SERVICE BULLETIN

APPLICABILITY: 2017MY Legacy and Outback 2.5i Premium Models with EyeSight

NUMBER: 07-121-17

SUBJECT: DTC B2902

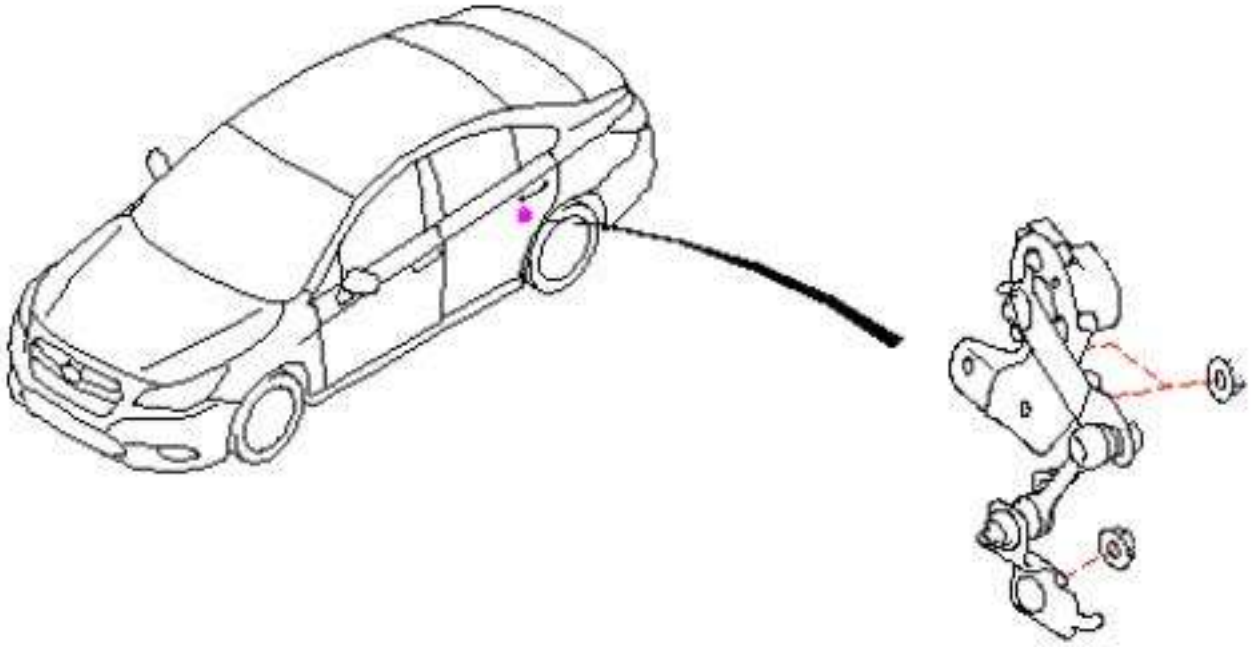
This bulletin provides a repair procedure to address DTC B2902 which may be stored erroneously due to a specification mismatch. This bulletin applies to a very limited number of early-production 2017 model year vehicles without the auto headlamp leveling (AHL) feature only. **Having the incorrect control module installed has absolutely NO effect on normal headlamp system operation and does not cause any warning lamp(s) to illuminate.** The repair involves replacing the headlamp control module.

The part number for the correct specification headlamp control module is **84051AL080**.

If DTC B2902 is stored in the Headlight Control System, confirm using the VIN and the Subaru Electronic Parts Catalog whether or not the vehicle should be equipped with the Headlamp Leveler sensor. If the vehicle is not equipped with the Headlamp Leveler Sensor, install the new (84051AL080) module. If equipped with the sensor, diagnose the DTC as per the applicable Service Manual.
